COUNCIL ASSESSMENT REPORT

PLANNING ASSESSMENT REPORT – SYDNEY EASTERN CITY PLANNING PANEL

2017SCL060, Nos. 27 - 33 Everton Road Strathfield – BD.2016.152

Figure 1 - Ground Level Plan (Revision C) - Source ARC Architects

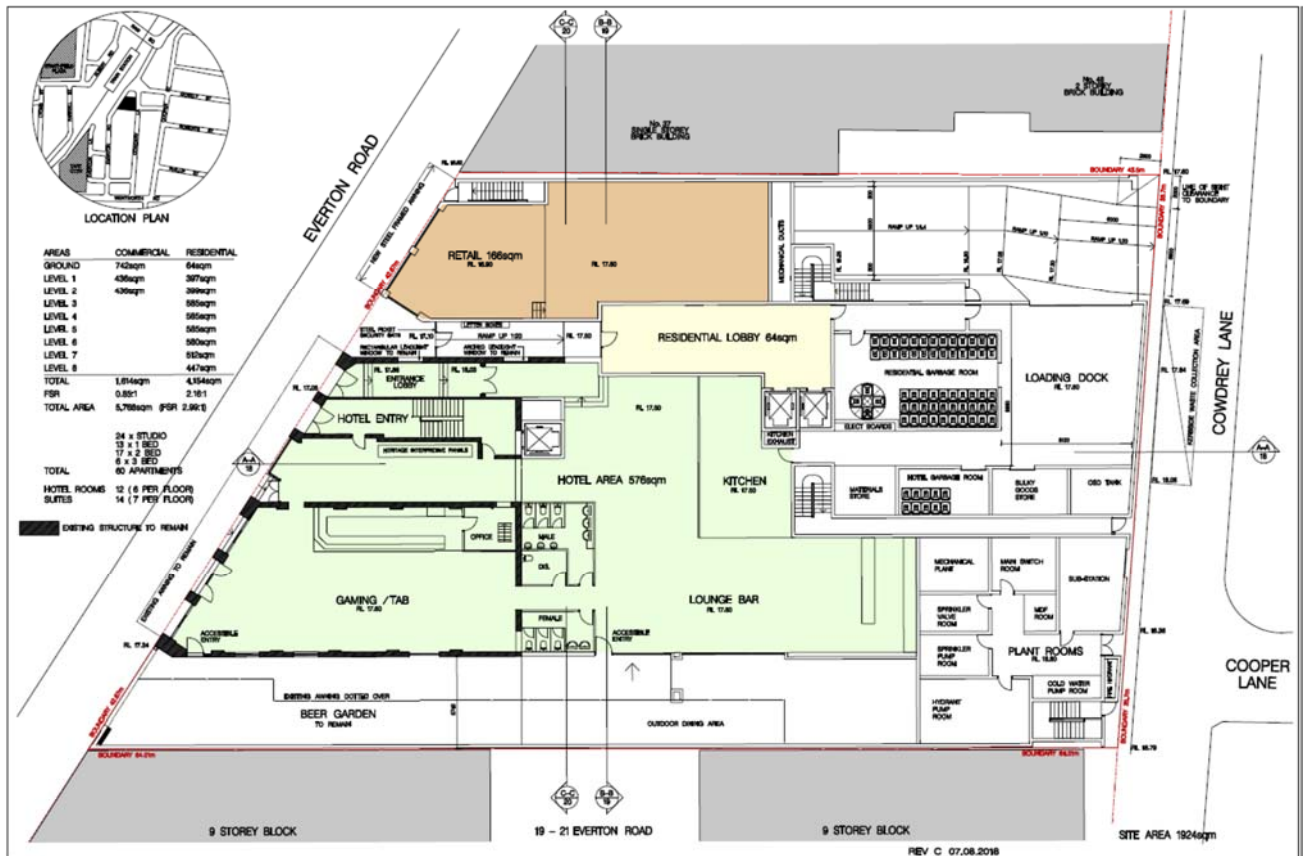
8.11.2018	<p>Final plans and details received dealing with the above matters. These are the subject of this report.</p>
